Logstacker Service Parts

New Spindle Design

216151 (OLD) VS 248619 (NEW)
SHADED AREA SHOWS INCREASED PROFILE OF NEW PART COMPARED TO OLD PART

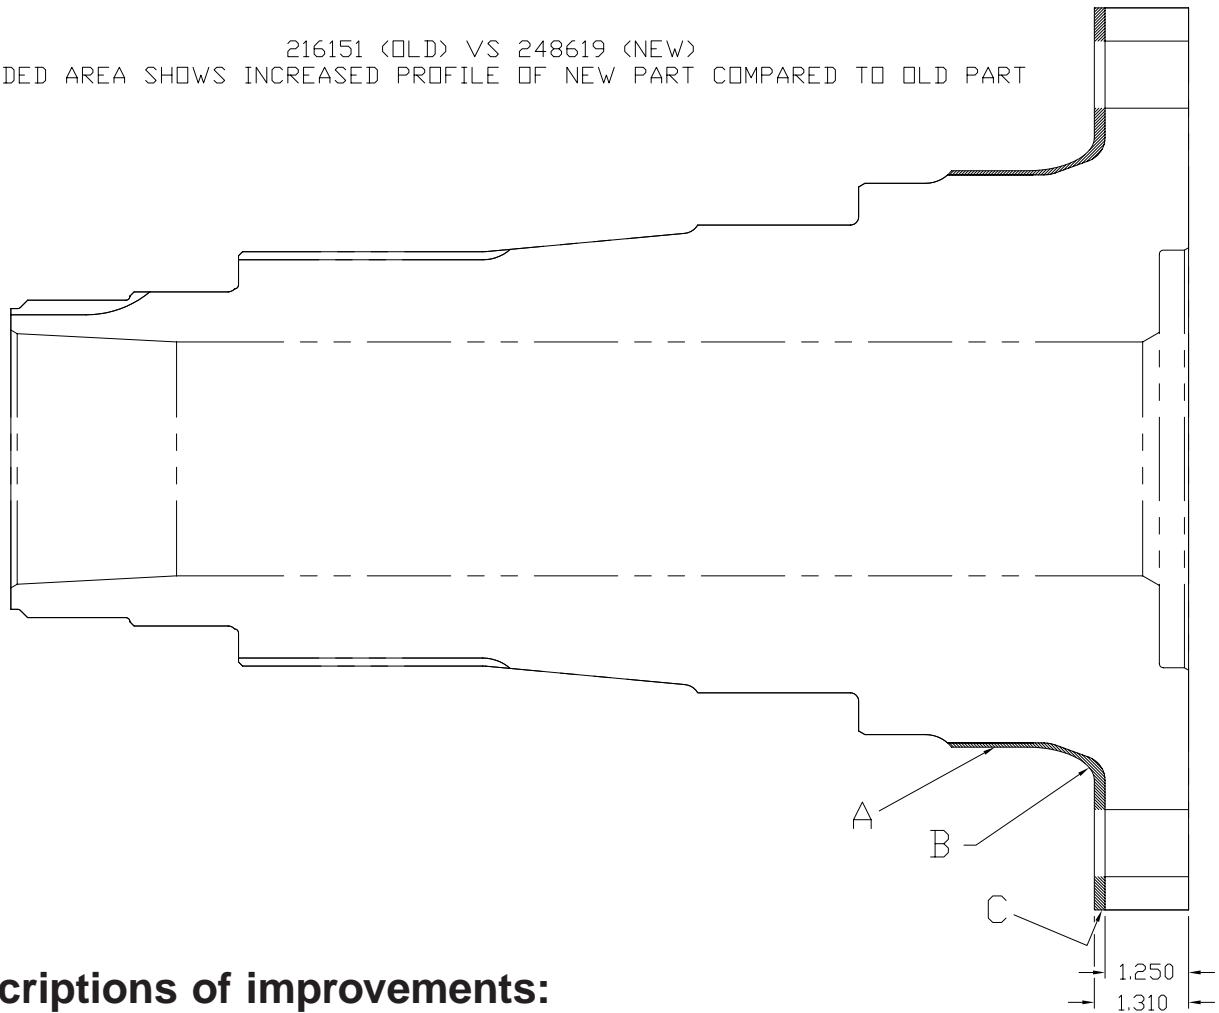
Descriptions of improvements:

A: Increased diameter behind seal area.

B: Ellipse transition instead of radius to uniformly distribute stresses.

C: Increased mounting flange thickness.
(216151 is 1.250" thick / 248619 is 1.310" thick)

All of the above improvements result in a theoretical increase in fatigue life of 6.8X.
